Environmental Effects of Residue Storage Facility

Section 12**Environmental Effects of Residue Storage
Facility****9 Environmental Effects of the RSF (1, 20)**

Farmer Creek and Six Mile Creek Sub-Catchments at Fairview

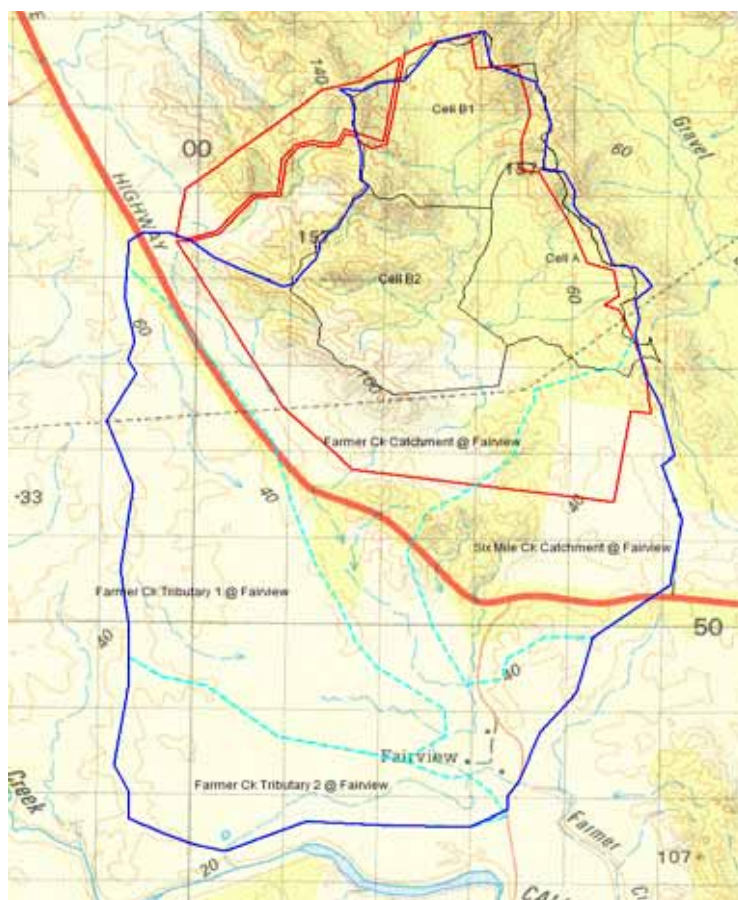
(20) A respondent has advised that the EIS has not recognised or considered the impact of the construction of the RSF in the catchment of Six Mile Creek and the resultant impact it will have on "Fairview".

The Fairview property is located adjacent to Farmer Creek downstream of the RSF. The catchments contributing to flows in Farmer Creek at this location are shown in the following figure.

As each RSF cell is constructed it will remove a portion of the Farmer Creek catchment and potentially affect Farmer Creek flows at Fairview, the respondent's property downstream of the RSF. This loss of catchment area will last for the operational life of each cell. Once the cells are full, they will be covered and rehabilitated with the surface runoff being discharged back into Farmer Creek thus restoring most of the pre-RSF flows, except for RSF-A which would discharge into the adjacent catchment to the east.

The following table summarises the loss of catchment area from each of the three RSF cells and the percentage they represent of the total Farmer Creek and Six Mile Creek catchment area at Fairview. The percentages relate to the situation prior to cell rehabilitation and the return of runoff to the downstream catchment. The loss of catchment area approximates to the potential loss of water flow in Farmer Creek although that would depend on the extent of storm flow throughout the catchment.

Should this 20% loss of catchment area result in an appreciable loss of water supply at Fairview, GPNL will enter into an agreement with the entitlement holder for alternative supplies.

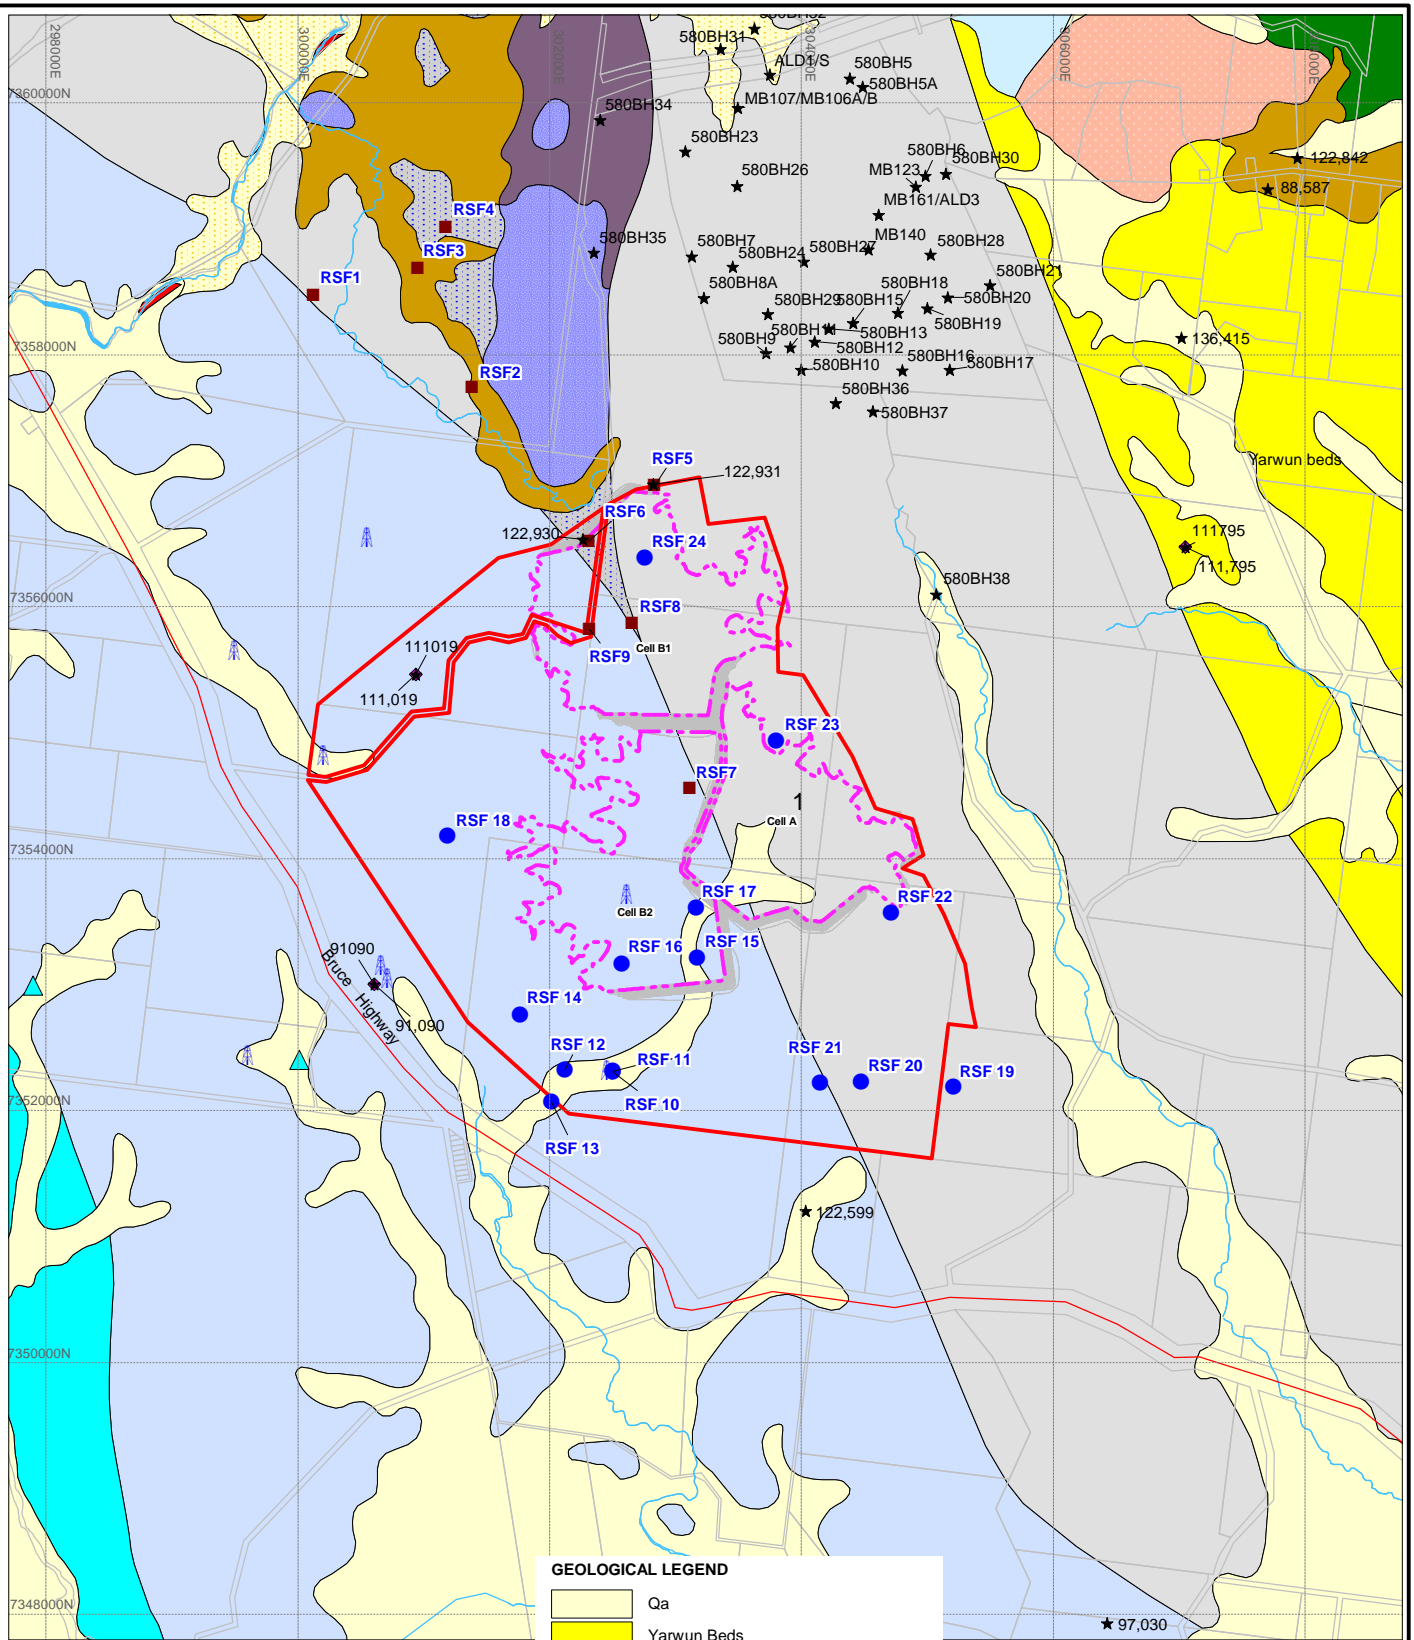
EPA advised that investigations should be undertaken so that geological sections can be presented showing the stratigraphic units present under the RSF site. Maps and plans should be presented showing the locations of any fissure lines, fault zones, or permeable layers. The potential of these features to carry flow from under the proposed RSF to down gradient areas should be investigated. Sub-surface conditions upstream and downstream of the main southern embankment of the proposed RSF should be included in the investigation. The regional groundwater table should be mapped and the groundwater contours for the area under and around the site should be shown on a suitable plan.

Investigation holes should be located both inside and outside the proposed footprint to allow ongoing monitoring of areas potentially causing, and areas potentially affected by groundwater fluctuation. The groundwater contours and directions of flow both inside and outside the RSF should be established. This data should be collected from all sides of the RSF site. Enough geological and hydrogeological information should be collected to establish current groundwater gradients and likely future gradients inside and outside the RSF. Bore logs should be presented and hydraulic conductivity testing should be undertaken for all permeable strata which is intersected by drilling.

The locations of bore holes or investigation trenches used in this investigation and the reasons for their locations should be recorded. All of the drill holes should be deep enough to reach an aquifer connected to the water table. The bore holes should be cased and capped in such a way that future access is possible, and that fluctuations of water levels in the bores can be measured as required in the future.

A further geological and groundwater assessment of the RSF site has been undertaken and is presented in Appendix K. It has been based on a review of available information and data collected on-site. Nine groundwater monitoring bores were installed in April 2006 and a further fifteen bores were installed in August 2007. The locations of these bores are shown on Figure 9.1 and the bore logs are presented in Appendix K.

Groundwater in the vicinity of the RSF site mainly occurs within fractures and pore spaces of the regional sedimentary bedrock units. The two relevant sedimentary bedrock aquifer units are the Late Devonian to Early Carboniferous Mount Alma Formation and the Rockhampton Group.

The faulted contact between the two bedrock units trends northwest-southeast through the RSF site. The contact is along a regional fault system, with a Late Permian gabbro intrusion north-west of the RSF, likely a by-product or cause of the structural deformation event. This gabbro intrusion lies between the two sedimentary bedrock units and has an associated layer of greenstone on its adjacent contact boundaries. Structural deformation in the area has produced dips in the strata of the Mount Alma

Figure: **9.3a**

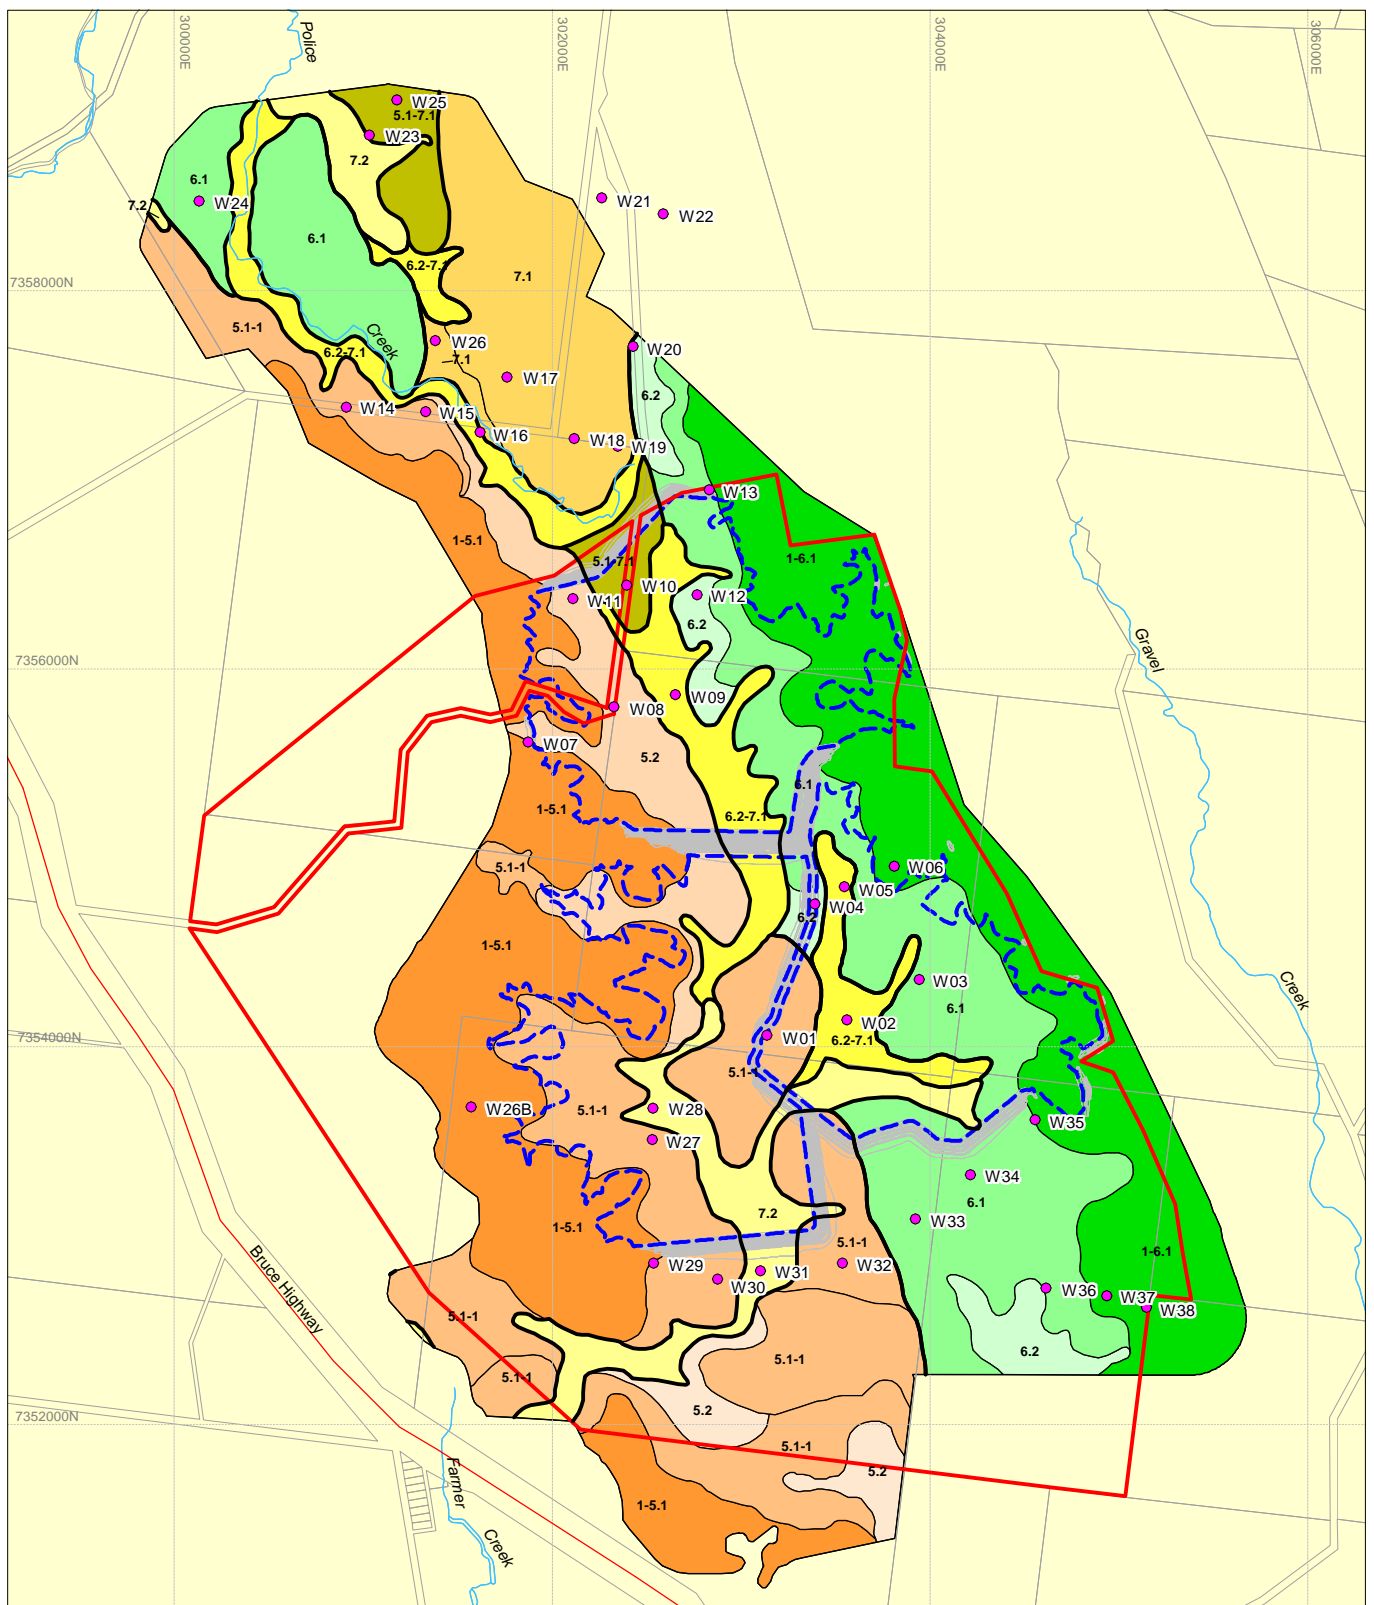
EPA has asked that details of the topsoil resources should be revised including: 1) the figures for topsoil resources in s9.1.2 be checked and amended as required. 2) A formal definition of the term 'RSF Study Area' should be included in this part of the EIS.

As discussed in Section 1.2.5, the design of the RSF has been modified from that described in the EIS. Consequently, the areas and volumes of topsoil and subsoil given in Table 9.1.2 of the EIS are no longer relevant. The soil types to be affected by the revised RSF layout are shown on Figure 9.3. The footprint of the now proposed RSF cells A, B-1 and B-2 is 679 ha. This area encompasses terrain units with topsoil resources of 1.168 million m³ and subsoil supplement resources of 1.606 million m³. Details of the terrain units and their respective soil volumes are given in the following table.

Based on the estimate given in the above table there are enough topsoil and subsoil resources available to cover the three RSF cells to an average depth of 0.4 m.
